**PLANNED UNIT DEVELOPMENT
& SUBDIVISION STAFF REPORT****Date: October 2, 2008****DEVELOPMENT NAME**

Providence Park POB West Subdivision, Resubdivision of Lot 1, Resubdivision of and Addition to Lot 1, Phase II

Planned Unit Development Approval to amend a previously approved Planned Unit Development master plan for Providence Park to allow a cancer treatment facility, and Subdivision approval to create 2 lots.

SITE PLAN

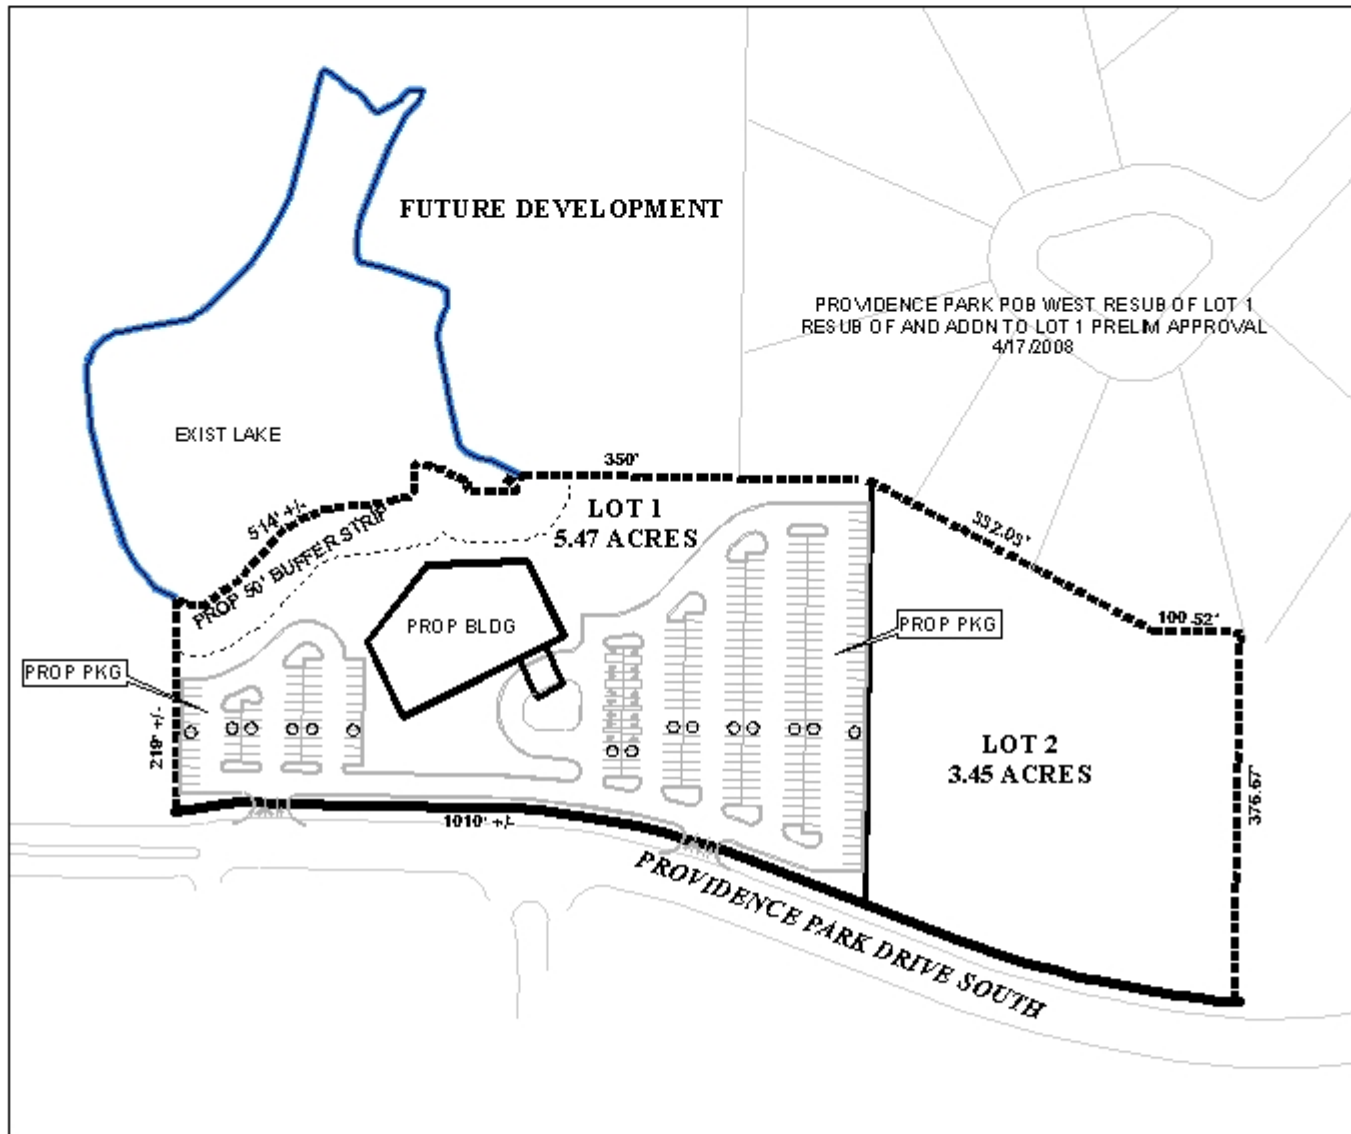
The overall PUD site plan shows the entire hospital development, however, several errors are evident. The “proposed” Bonefish Grill and Hampton Inn are now in operation, thus their labels should be revised. The overall site plan should also be revised to clearly delineate and label the public versus private portions of Providence Park Drive and any other private streets.

The proposed 60,000 square foot cancer center will require 200 parking spaces: 290 parking spaces are depicted on the site plan, however, the data on the plan states that 293 spaces are provided. It should be pointed out that such a facility will generate waste, and there do not appear to be any provisions for dumpster or other service entrances for the building. Furthermore, there is no indication of any free-standing HVAC or generator systems, which such a building would likely have. The site plan should be revised to show the correct number of parking spaces, any proposed dumpster areas or service drives, and any proposed locations (generally) of free-standing HVAC or generator systems.

It should also be pointed out that no information is provided regarding the compliance of the site as it relates to the tree requirements of the Zoning Ordinance. It appears, however, that there will be adequate area for the required tree planting. The site plan for the cancer center should be revised to show compliance with the tree requirements (frontage, perimeter and parking) of the Zoning Ordinance.

As a site design note, the site plan depicts 16 handicap parking spaces with no sidewalk access to the main entrance. Persons parking in the handicap spaces will be required to cross traffic to enter the building. No pedestrian circulation is depicted on the site plan, nor are any sidewalks shown along Providence Park Drive: sidewalks will be required along the public street.

The site plan does not indicate curb-cuts which exist across from the site, particularly the entrance into Providence Estates, and the small office building. As changes to the location of curb-cuts affects site design and Traffic Engineering decisions, the location of the curb-cuts across Providence Park Drive from the site should be indicated.

- 1) Revision of the overall PUD site plan to show what is existing versus what is proposed (examples of Bonefish Grill and Hampton Inn);
- 2) Revision of the overall PUD site plan to clearly delineate and label all public and private streets;

- 3) Revision of the site plan to show compliance with the tree planting requirements of the Zoning Ordinance for the cancer center site.
- 4) Revision of the site plan to show any proposed service drives, dumpster locations, or freestanding HVAC or generator locations;

- 5) Revision of the site plan to depict existing curb-cuts across the street from the site;
- 6) Revision of the site plan information to correctly total the number of parking spaces;

- 7) Revision of the site plan to depict a sidewalk along Providence Park Drive, or submission of a sidewalk waiver application;
- 8) Compliance with Engineering comments (*Must comply with all storm water and flood control ordinances. Any work performed in the right of way will require a right of way permit. Must provide detention for any impervious area added since 1984 in excess of 4,000 square feet. Need to verify that the detention pond has sufficient capacity and is functioning properly.*);
